Memorandum

Borehole Flowmeter Review MORR 52027, John Vandenbrink

Response to OWRD Draft Preliminary Determination for Transfer Application T-13839

Figure 1. Results of borehole EM flowmeter logging in MORR 52027.

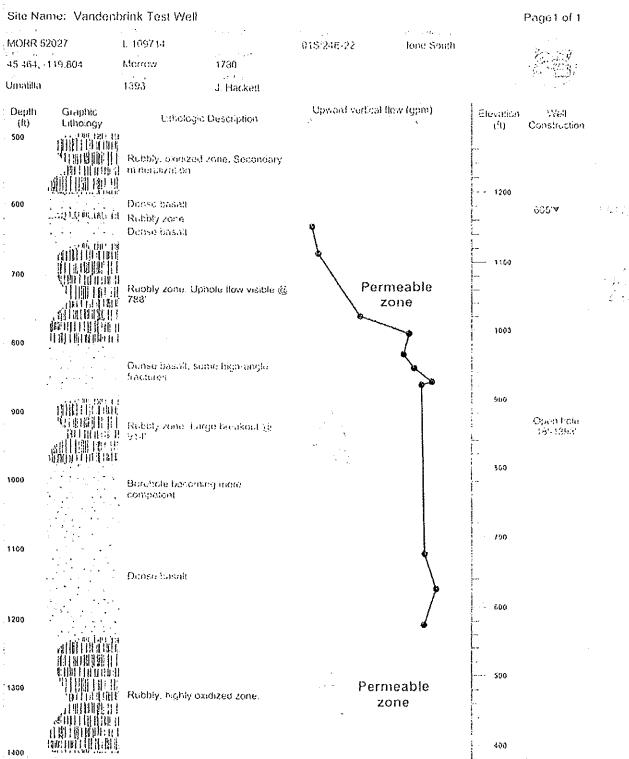
Maximum upward flow ranging from 2.81 gpm to 3.57 gpm was measured in the interval from 1205 feet to 784 feet bls (Table 1, Figure 1). Above 784 feet bls, a decrease in upward flow was observed at successive stations (1.41 gpm at 759 feet bls, 0.22 gpm at 667 feet bls) until flow ultimately decreased to nearly zero (0.04 gpm) at 629 feet bls (Table 1, Figure 1). The consistency of upward flow rates between 1205 feet and 784 feet bls indicates that vertical flow is entering the well below this interval and is exiting the well above it. Decreasing upward flow rates between 784 feet and 629 feet bls indicates that flow is exiting the well in this interval. The abrupt decrease in flow between 784 feet and 759 feet bls suggests that a significant portion of flow exits the well in this short interval while the remainder exits in the longer interval from 759 feet to 629 feet bls.

The results of the EM Flowmeter log survey generally agree with the findings of the video log survey, with both surveys identifying two aquifers (shallow and deep). However, results from the flowmeter survey indicate that the shallow aquifer occurs from approximately 670-800 feet bls, not 880-975 feet bls as was identified in the video survey. It is evident RECEIVED from the flowmeter survey that the deep aquifer is losing at least 3 gpm to the shallow aquifer. As an average rate, 3 gpm equates to a loss of 4320 gallons per day, 1.57 million JUL 15 2022 gallons per year, and a total of 4.73 million gallons in the three years since the well was drilled.

The EM flowmeter log of MORR 52027 indicates the well commingles two aquifers in the Columbia River Basalt Group, Measured vertical flow was approximately 3 gpm from the deep aquifer to the shallow aquifer. The well must be constructed to meet the minimum construction standards for Water Supply Wells described in OARs 690-200 and 690-210. Specifically, the well must not allow commingling of waters from multiple aquifers (690-200-0043) and must be eased and sealed at least five feet into solid, uncreviced, consolidated rock overlying the water-bearing rock formation (690-210-0150). To avoid commingling in the well, either the deep or shallow aquifer must be sealed off. According to the drillers' log, most of the production is from the deep aquifer; the following recommendation assumes the shallow aquifer will be sealed off. In addition to sealing off the upper aquifer, the well must be eased and scaled into solid, dense rock overlying the productive aquifer. While the base of the upper aquifer occurs at a depth of 800 feet bls, the borehole does not appear to be solid or uncreviced until 815 feet bls. Accordingly, the well should be eased and sealed to a minimum of 820 feet below land surface. This case and seal depth shall supersede Condition 3 of permit G-17360 (case and seal to 1055 feet bls).
